SUB-COMMITTEE ON STABILITY AND
LOAD LINES AND ON FISHING VESSELS
SAFETY
55th session
Agenda item 9

SLF 55/INF.2
9 November 2012
ENGLISH ONLY

**DEVELOPMENT OF PROVISIONS TO ENSURE THE INTEGRITY AND UNIFORM
IMPLEMENTATION OF THE 1969 TM CONVENTION**

Information collected by the correspondence group

Issue 1.b – Determining Least Moulded Depth (LMD) (SLF 53/5, annex 4, issue No. 1)

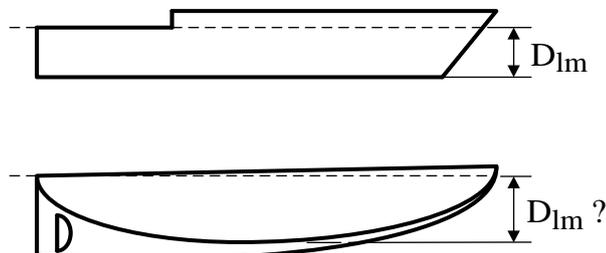
The term "least moulded depth", which is the basis for the length assignment, is undefined, and various interpretations of the term can lead to length dimensions varying on the order of 5% or more.

Questionnaire responses: Many different views were expressed on the various proposals. Most agreed, or agreed subject to changes, with the proposal to use the smallest depth along the length of the ship, with two respondents disagreeing on the grounds that the approach does not satisfactorily address configurations like those depicted in the lower of the two figures above, while several respondents made suggestions along the lines that in such cases, the least moulded depth could be taken at or near amidships. Another recommended using a tangent line approach instead, that takes into consideration raked straight keels, but with the moulded depth taken amidships in cases of curved keels. Two respondents highlighted differences between the TM Convention and Load Lines Convention definitions related to least moulded depth, including the definitions of the upper and freeboard decks, with a third noting that the Load Lines Convention also lacks a definition of least moulded depth, and a fourth describing a harmonization approach used by an Administration that could be applied, even for ro-ro ships, to arrive at consistent treatment. Several cited the need for illustrative figures.

Proposals: The group considered six proposals. One proposal recommended taking the length measurement at the underside of the upper deck in cases where it is not possible to establish a minimum depth due to a curved keel. Two proposals recommended, in effect, that the least moulded depth be defined as the smallest moulded depth along the length of the ship (i.e. measured from the top of the keel to the upper deck). One proposal recommended that the least moulded depth be taken as the vertical distance between the top of the keel at its lowest point and the underside of the upper deck at its lowest point. One proposal recommended using the Load Lines Convention moulded depth definition for ships with inclined keels.

Issue 3.a – Requirement for a deck above to bound enclosed space (SLF 53/5, annex 4, issue No. 9)

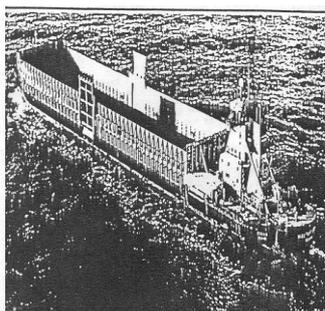
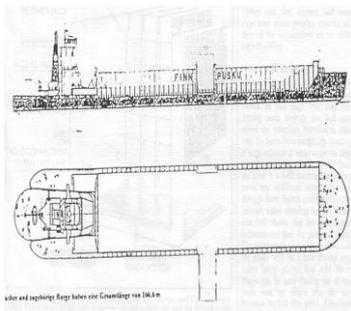
Regulation 2(4) is unclear as to whether a space not within the ship's hull must be bounded by a deck above, in order for that space to be considered enclosed and therefore included in the total volume of all enclosed spaces (V). The issue was discussed at SLF 30 (SLF 30/WP.4), and a decision made that, in effect, a deck above was required to bound an enclosed space, although there was not universal agreement on this interpretation. Under this interpretation, the space bounded by high coamings is not enclosed. Subsequently, IMO has taken different approaches, with volumes inside coamings of open-top containerships included in V, while volumes inside of coamings of dockships have been omitted.

Questionnaire responses: Most agreed with the proposals recommending that a deck above not be a condition for a space to be considered enclosed, and disagreed with the proposal advocating that such a condition be applied. Respondents expressed different views regarding whether two or three "sides" were necessary to bound enclosed space and if the "sides" should be connected as a condition for such treatment. One respondent commented that in performing such an evaluation, a deck above was considered to be a "side" in this context. Two respondents questioned a proposed height criterion of 1.5 m that was included in separate proposals, arguing against treating structures with low sides any differently, while one respondent recommended that any bulwarks required by the Load Lines Convention should not be considered "partitions". Among those advocating a linkage between treatment as enclosed space and the usage of the space, some argued in favor of including the space in tonnage if the space is used, or intended, for carriage/appropriation of cargo or stores, with another arguing for inclusion on condition that the space is not equipped with lashing equipment. One respondent cautioned against developing detailed interpretations not rooted in the regulations of the TM Convention, while another argued for keeping rules general, because of the large number of different structures that must be addressed. Most disagreed with the proposed "1 in 4 rule", with respondents expressing concerns over the proposal's deviation from the TM Convention, its complexity, the possible misuse of novel craft provisions, and the potential for influencing future designs and adversely impacting safety.

Proposals: The group considered eight proposals. Several were along the lines of considering enclosed space to be bounded by the hull, by a deck, or by bulkheads or partitions without the need for a deck above to bound an enclosed space. Among these, various different approaches were recommended for:

Issue 3.d – Treatment of spaces underneath overhangs (SLF 53/5, annex 4, issue No. 12)

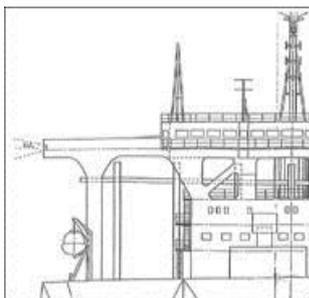
Under the enclosed space definition of regulation 2(4), space bounded by a deck above is considered enclosed space, and can be excluded only if it meets the excluded space requirements of regulation 2(5). It appears that bridge wings and other overhangs do, in fact, bound enclosed space under this definition, even though as a matter of practice such spaces are generally ignored.

Questionnaire responses: A majority of respondents generally agreed with the proposals whose effect would be to not include spaces beneath bridge wings and similar structures regardless of whether or not fitted with means for securing cargo or stores. Expressing a contrary view, several respondents questioned the authority to treat any space below an overhead deck as, effectively, unenclosed. One respondent emphasized the difference in addressing space below a bridge wing that is immediately above a deck, as opposed to a bridge wing that is several decks above a deck. Several respondents expressed support for expanding interpretations to address structures that do not extend side-to-side. Two respondents commented on the effect of supporting stanchions, advocating a longitudinal maximum restriction of 0.6 m, instead of the 1 m² / 1 m³ restriction discussed at SLF 29.

Proposals: The group considered five proposals. Two proposals recommended that open spaces below bridge wing structures not be included in tonnage. One proposal offered an approach, discussed at SLF 29, that addresses treatment of spaces beneath a variety of overhanging structures, including those having supporting stanchions, without regard to whether a structure extends side-to-side. Under this approach, the space must meet the requirements of regulation 2(5) for an excluded space in order for it to be excluded from tonnage (e.g. not fitted with means for securing cargo or stores). Another proposal provided for excluding any space bounded by an overhang such as a bridge wing only if it satisfies all of the regulation 2(5)(b) or (c) conditions. Another recommended that, in general, any space beneath a cantilevered overhanging structure like a bridge wing (i.e. one connected to ship's structure on only one side and open both fore and aft) not be considered an enclosed space, whether or not fitted with means for securing cargo or stores.

Issue 3.f – Treatment of hull spaces of complex shape (SLF 53/5, annex 4, issue No. 23)

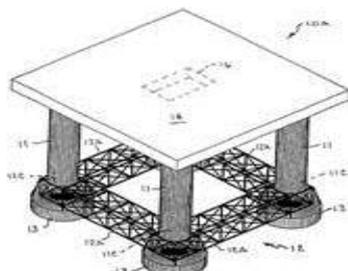
Column-stabilized units, such as semi-submersible drilling units, and ships of similar design are often fitted with cross-bracing, for which volumes can be extremely difficult to calculate.

Consideration should be given to developing guidance on how to treat such volumes in an efficient and consistent manner.

Questionnaire responses: Most agreed, with comments, on the proposals to develop clear definitions and include in tonnage appendages and bracings larger than 1 m³ in volume, with less agreement on the remaining proposal related to the specific definitions. Several respondents commented to the effect that if definitions are clear, interpretations regarding allowable computational approaches could add unnecessary complexity, while another cautioned against including definitions that are overly detailed. Several respondents questioned the application of both volume and area criteria in measuring smaller spaces, with one advocating inclusion of the space in tonnage if the volume and/or area criteria are exceeded. Another questioned the treatment under the proposed definitions of a hollow appendage fitted to the hull that is open to the hull at the point of connection.

Proposals: The group considered three proposals. One proposal recommended development of clear definitions as to what should and should not be included in tonnage, with the method for determining volumes left to the naval architect's discretion. Another proposal recommended specific definitions for the terms "hull" and "appendage" based on discussions at SLF 30, with appendages to include structures fitted on the outer surface of the hull, whether solid or bounded by a metal cover. The third proposal recommended the inclusion in tonnage of all appendages, bracings, and other linear hull elements that are larger than 1 m³ in volume, with provisions to approximate volumes of such items.

Issue 3.j – Enclosed space versus excluded space (correspondence group Round 1)

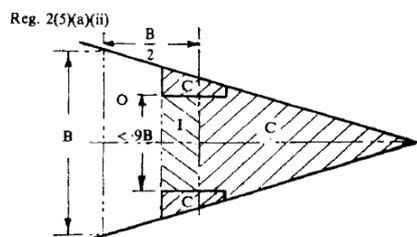
The TM Convention is inconsistent in how it describes and treats spaces that are excluded from tonnage. The Convention states, in effect, that "excluded" means "excluded from the total volume of all enclosed spaces (V)". However, associated figures indicate that "excluded" means "not enclosed". It appears that the labeling in the figures ("O" (for "Open"), "C" (for "Closed") and "I" (for "Included")) derive from that used in proposals A & C discussed at the 1969 Tonnage Conference, which eventually became the basis for the gross tonnage measurement system of the Convention, but which did not use the term "excluded".

Questionnaire responses: A majority of respondents agreed in principle with the first proposal, with one commenting that the matter could be satisfactorily treated through interpretations and another suggesting that the term "excluded" be interpreted as "enclosed but excluded". Most agreed with the second proposal, with no disagreement, although two respondents expressed preference for addressing the matter through interpretations. Another respondent expressed the view that an interpretation cannot supersede a provision of the TM Convention, and that the text and figures in the Convention need to be amended accordingly.

Proposals: The group considered two proposals. One proposal recommended establishing the interpretation that an excluded space is an enclosed space in all cases, and revising the appendix 1 figures accordingly, if the TM Convention is amended for other reasons. A second proposal recommended, if there is agreement, to amend the TM Convention with a broader definition with details on how to identify and address excluded spaces, knowing that in all cases such spaces are "indoors" (enclosed).

Issue 3.k – Mobile cranes (correspondence group Round 1)

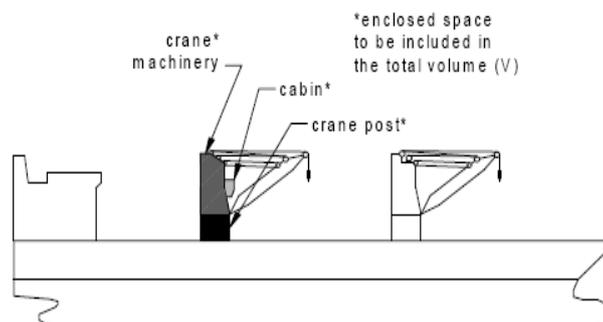
A clear definition of the term "mobile" as used in TM.5/Circ.5 should be given, as the term can lead to misunderstandings. A generally-accepted definition of mobile crane is one that is easily moved from one location to another. For cranes like the one shown in the picture below, the upper part rotates around its own axis; it does not actually "move" from its location.

Questionnaire responses: There was little agreement on the proposal. A respondent who agreed, with changes, recommended establishing a detailed definition of mobile crane along the lines of a machine mounted on a non- or self-propelled, crawler- or wheel-mounted, mobile base, that is capable of travelling over a supporting surface without the need for fixed runways. One respondent who disagreed commented that machinery, meaning revolving cranes, movable loading/unloading equipment and other similar items or structures, should not be included in tonnage. Another expressed the view that crane structures, regardless of type, should be included in tonnage. Another questioned why the term "mobile crane", rather than a more generic term, is used, citing the example of a spreader beam for a heavy lift ship, which is portable, but stowed on deck.

Proposals: The group considered a single proposal. The proposal recommended that only those cranes of a type which displace from one point to another (e.g. gantry cranes) should be exempted (i.e. not included in tonnage).

Issue 3.m – Spaces fitted to outer structure boundary (correspondence group Round 1)

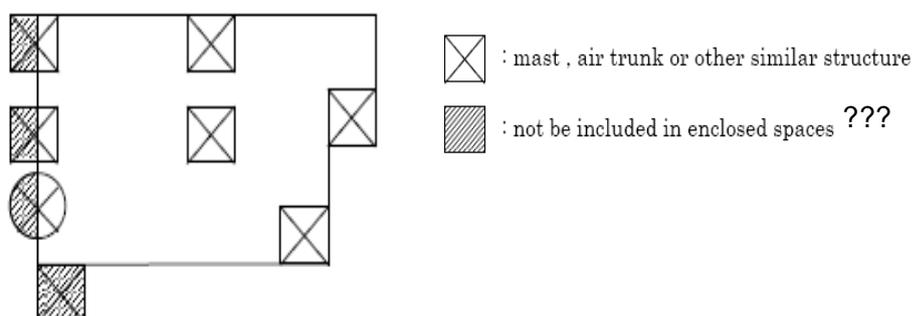
Clarification is required regarding treatment of the part of a mast, air trunk and other similar space fitted to the outer surface of a structure's boundary.

Questionnaire responses: An equal number of respondents agreed, or agreed with changes, as disagreed with the proposal. Three respondents commented that per paragraph 4.6 interpretations of TM.5/Circ.5 (regulation 2(4)), spaces not separated on all their sides should be included in tonnage. Another respondent expressed preference for removing the sectional area criterion from the existing interpretations altogether to avoid impacts on ship designs, but recommended that the proposal be modified to take the cross-sectional area in a direction perpendicular to its longitudinal axis, should this view not prevail.

Proposals: The group considered a single proposal. The proposal recommended that the part of a space fitted to the outer surface of a structure's boundary having at least three exposed sides and having the largest cross-sectional area in the longitudinal direction of the structure not exceeding 1 m² should not be included in tonnage.

Issue 5.c – Excluding space opposite an end opening as a recess (SLF 53/5, annex 4, issue No. 17)

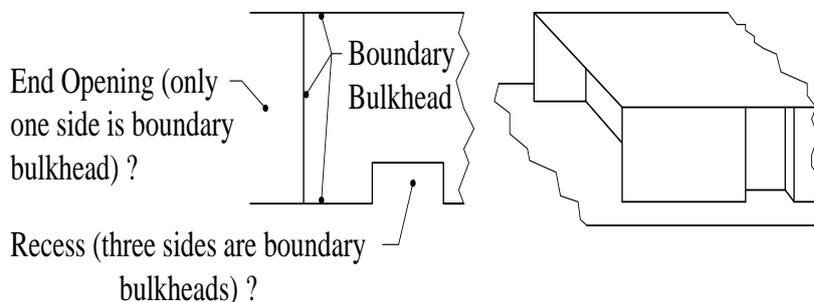
If an opening in the end of a structure is treated as a "recess" under regulation 2(5)(e) instead of a "space opposite an end opening" under regulation 2(5)(a), up to twice the

amount of space may be excluded. Various approaches have been used to address this issue, including the establishment of definitions for the term "boundary bulkhead" that would preclude treatment of a "typical" end opening as a recess. Clarification would be helpful to ensure consistency and avoid misuse.

Questionnaire responses: A majority of respondents agreed with all of the proposals. The proposal receiving the most support was the one recommending that three boundary bulkheads along with a deck above be considered as necessary conditions for bounding a recess. One respondent expressed support for the linkage to boundary bulkheads, but disagreed with the stipulation for three, instead of two, bulkheads without amending the TM Convention to revise figure 10. Along similar lines, another respondent cited the need to amend the TM Convention to implement this proposal, and commented to the effect that figure 10 illustrates a "real" two-sided recess. Among the other comments provided, one respondent expressed the view that a recess extending for more than one tier should be not included as enclosed space. Another respondent commented that regulation 2(5) should be expanded in the context of applying recess provisions, to ensure that gross tonnage is reflective of overall size. Another commented that certain open spaces whose purpose is simply to provide protection for the crew should not be penalized (i.e. by including them in tonnage).

Proposals: The group considered seven proposals. Three proposals recommended that a recess be defined in terms of a space bounded on three sides by boundary bulkheads, with one of these proposals recommending an additional condition that a recess also be bounded by a deck above, on the basis that otherwise the space would not be considered enclosed, and a second recommending that qualifying side recesses be addressed. Another proposal recommended that a recess be defined in terms of space bounded on at least two sides by boundary bulkheads, and offered a definition of the boundary bulkhead along the lines of a bulkhead separating an enclosed interior space from the surrounding weather. One proposal cited figure 10 of annex 1 to the TM Convention, and questioned whether the two boundary bulkheads shown in the right hand portion of the figure, in fact, bound a "real" recess, and if not, whether three boundary bulkheads should be required. Another proposal offered a number of diagrams to be used in evaluating a variety of spaces, including recesses, reflecting views offered at an international meeting of tonnage experts held in 1990. The remaining proposal recommended that a recess opening be considered to extend from deck to deck notwithstanding the fitting of a curtain plate of a depth not exceeding by more than 25 mm the depth of the adjoining deck beams.

Issue 5.h – Adjoining Deck Beams on End Openings (correspondence group Round 1)

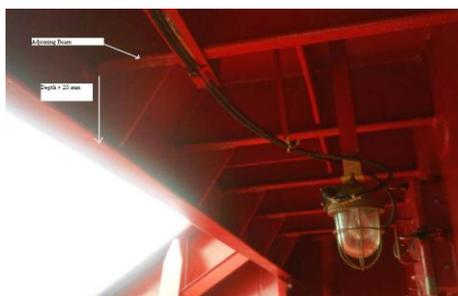
In applying the 25 mm curtain plate depth criterion of regulation 2(5)(a)(i), it is unclear how to treat additional plates that extend below the bottom edge of an adjoining deck beam and act as stiffeners to the curtain plate, as shown in the pictures below.

Questionnaire responses: Most respondents agreed with the proposal, or agreed subject to changes, and no respondents disagreed. One respondent who agreed commented that this criterion might be circumvented through the fitting of excessively deep brackets, and suggested that the current criterion be replaced with something less prescriptive based on the structure's height (e.g. 90%) if the TM Convention is amended for other reasons. One respondent commented that general guidance on this matter would be helpful.

Proposals: The group considered a single proposal, recommending that sketches be provided to illustrate that the depth criterion is applied to the portion of the curtain plate below the lowest extremity of the adjoining deck stiffeners.

Issue 5.j – Height of side opening railings (correspondence group Round 1)

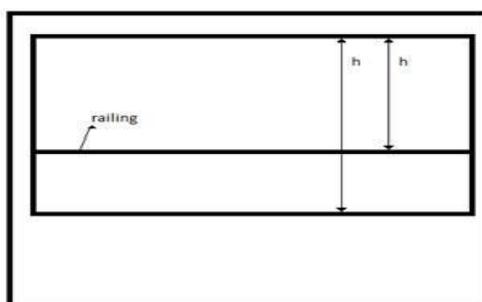
Under regulation 2(5)(c), it is not clear, in the case where a horizontal railing is present, whether the opening height above the railing should be considered when applying the one-third height criterion, along the lines of treatment of railings under regulation 2(5)(b).

Questionnaire responses: Most respondents disagreed with the proposed solution. Two respondents highlighted the differences in the language of regulations 2(5)(b) and 2(5)(c) on the matter of railings, concluding that because rails are not called out in regulations 2(5)(c), they should be ignored under these provisions. One respondent commented that a railing should not be treated as a part of the bulwark/side shell in this context, while another commented that a simple railing (2 or 3 cm) should not be considered as a closing structure. Another respondent commented that the provision of a safety feature should not be penalized. One respondent who agreed with the proposal, with changes, expressed the view that the height should be measured from the top of the railing to the top of the erection (below the deck plate).

Proposals: The group considered a single proposal, recommending that the existence of a horizontal railing should be taken into consideration when applying height criteria, in the same manner as is done under regulation 2(5)(b).

Issue 6.a – Treatment of spaces inside the hull as open to the sea (SLF 53/5, annex 4, issue No. 25)

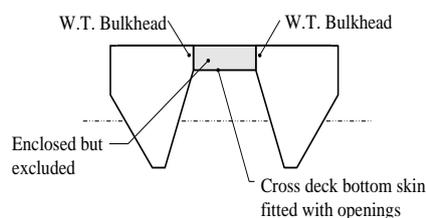
Regulation 6(3) allows volumes of spaces open to the sea to be excluded from tonnage. The degree to which a normally flooded or free-flooding space inside the hull is considered "open" has required interpretation, in view of the criteria of regulation 2(5) that requires spaces above the upper deck to be reasonably "open" before they may be excluded. Further, designers have sought to reduce tonnage or principal dimensions through contrivances to treat otherwise enclosed spaces as spaces that are "spaces open to the sea". Examples include:

- .1 standpipes in underdeck voids and ballast spaces;
- .2 holes in bows and sterns of ships of all types; and
- .3 holes in cross-deck structures on multi-hull ships.

Questionnaire responses: Most respondents either agreed with the four proposals related to establishing a free communication condition, or agreed with these proposals subject to changes. Among the many comments provided on these four proposals, three respondents questioned how the area of a bounded space would be ascertained and the specific percentage to be used, two expressed the view that the presence of gratings should not cause an otherwise excludable space to be included in tonnage, one cautioned against overly prescriptive requirements, one commented that spaces of less than 1 m³ in volume should be ignored, and three expressed the need for further development of the proposals. One respondent questioned the need to develop a definition for the term "hull", suggesting instead that in interpreting the regulation 6(3) "open to the sea" language, the focus should be on the regulation 2(4) language about "partitions" that bound enclosed space. This

Proposals: The group considered seven proposals. Four of the proposals in some way sought to establish, as a condition for exclusion, the free communication with, or unrestricted influx of water to, the space. Of these, one proposal recommended establishment of an area criterion for the opening relative to the area of the bounded space (e.g. 75%), and two recommended that the space not contribute to the buoyancy of the ship nor be fitted with means for securing cargo or stores as a condition for exclusion, with one recommending the additional restriction that the space not be appropriated for the stowage of cargo or stores in any form. Two proposals recommended that an interpretation of the term "hull" be developed, with one suggesting that this term not include fairings of a non-structural nature. Another proposal recommended that if the TM Convention is amended for other reasons, the exclusion of space open to the sea be made mandatory, rather than optional, to help ensure uniformity. Another recommended that the existing TM.5/Circ.5 interpretations be expanded to provide more precise examples, in order to reduce the number of "similar spaces" which are not yet defined.

Issue 6.b – Treatment of spaces outside the hull as open to the sea (SLF 53/5, annex 4, issue No. 26)

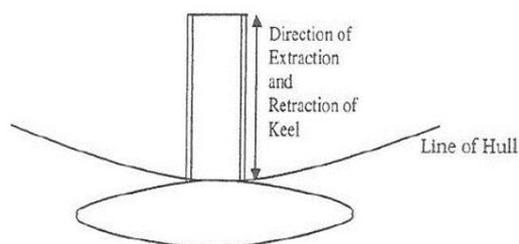
Regulation 6(3) allows volumes of spaces open to the sea to be excluded from tonnage. The degree to which a space outside the hull is considered open to the sea has required interpretation in cases where free communication between the space and the sea is in some way restricted. Examples include:

- .1 "wells" or "pockets" for retractable keels and stabilizers with fairing plates;
- .2 semi-weatherproof storage spaces in the stern step areas of yachts that are protected from the sea by non-watertight closures;
- .3 bow thruster tunnels fitted with doors to reduce underwater resistance; and
- .4 sea valve recesses ("sea chests") fitted with fine mesh strainers.

Questionnaire responses: Most respondents either agreed with all of the proposals, or agreed subject to changes. One respondent expressed the view that the presence of a grate should not preclude a space from exclusion. Another respondent expressed support for further development of the proposal related to constructional features limiting free exchange

Proposals: The group considered four proposals. Two proposals recommended that if the space is capable of being closed by a closing device, then the space should be included in tonnage, with one of these proposals stipulating that such a closure could either be watertight or non-watertight, and the other stipulating that the presence of a grating should not preclude treatment as open to the sea (e.g. sea chest recesses are always treated as open to the sea). Another proposal recommended establishing interpretations to the effect that for a space to be considered open to the sea, the space must be below the upper deck, in free communication with the sea, and without constructional features that could prevent the free exchange of water. This proposal suggested allowing Administrations flexibility in evaluating such spaces, to include outflow calculations and area ratios, with the possibility of establishing related guidelines (e.g. one second for a space to empty). The remaining proposal recommended use of a comprehensive approach that was offered in a proposal under issue 6.a.

Issue 6.c – Treatment of moon pools (SLF 53/5, annex 4, issue No. 27)

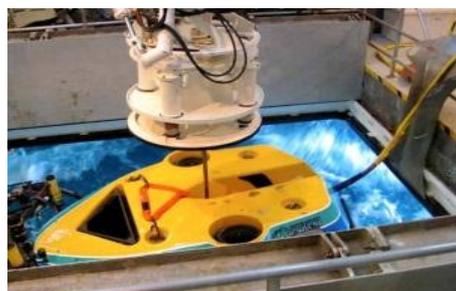
Moon pools and similar large "through hull" openings are sometimes fitted with covers or are otherwise covered from above by an enclosing structure within the ship's hull or above the upper deck. In addition, some moon pool wells are fitted with retractable doors at their lower extremities or at some distance from the keel, which in some cases serve as non-watertight fairings and in others as watertight closures. It is unclear as to whether spaces fitted with such covers or doors may be excluded as open to the sea under regulation 6(3), and if so, to the extent the space above the doors may be treated as excluded.

Questionnaire responses: Most respondents either agreed with all of the proposals, or agreed subject to changes. One respondent commented that closure criteria should address free communication with the sea, and referred to a proposal offered under issue 6.b. Another respondent expressed the view that closure devices fitted solely for safety should not be penalized, highlighting the difference between a closing device for a space carrying cargo, and one provided simply to prevent water egress on deck.

Proposals: The group considered four proposals. Two proposals recommended that when moon pools are fitted with any closing device, only that portion of the space below the closing device should be excluded, with one of these proposals stipulating that such a closure could either be watertight or non-watertight. Along similar lines, another proposal recommended the exclusion of the space underneath, provided the space is without means for securing cargo or used for cargo and entirely open. The remaining proposal referred to a comprehensive approach proposed under issue 6.a.

Figure 1: A ship fitted with spaces between the inner skin and the outer shell to fill air for buoyancy

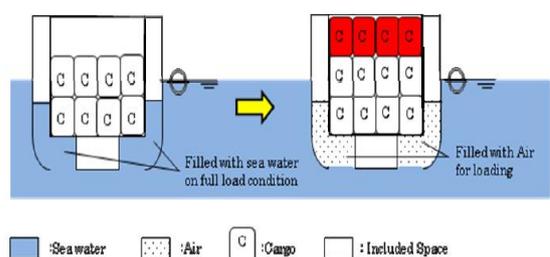
- .1 ships with open bottom spaces between the inner skin and outer shell that hold air to gain additional buoyancy (figure 1); and
- .2 ships with cargo spaces between cross-deck structures with gratings openings to the sea (figure 2). The volumes of such spaces can be substantial, relative to the total volume of the ship.

Questionnaire responses: Most respondents either agreed with all of the proposals, or agreed subject to changes. In commenting on the proposal regarding free communication with the sea, one respondent cautioned that the language must address stern chutes and hawse pipes. Another respondent stated agreement in principle with this proposal, subject to including the provision that a space open to sea may not be excluded if used for the carriage of cargo, and noting that this approach would address situations where trapped air could prevent water from entering a tank. Another respondent expressed the view that there should be no linkage between exclusion of a space as open to sea and whether or not the space is buoyant or carries cargo or stores.

Proposals: The group considered four proposals. Two proposals recommended the interpretation along the lines that spaces open to the sea, used or appropriated for holding cargo, and/or contributing to the buoyancy of the ship, should be included in tonnage. One proposal recommended the interpretation that the space must be in free communication with the sea at all times. The remaining proposal recommended that tonnage not be calculated with respect to the use of a space, but that spaces that are not always open to sea or are fitted with a means for securing cargo cannot be excluded.
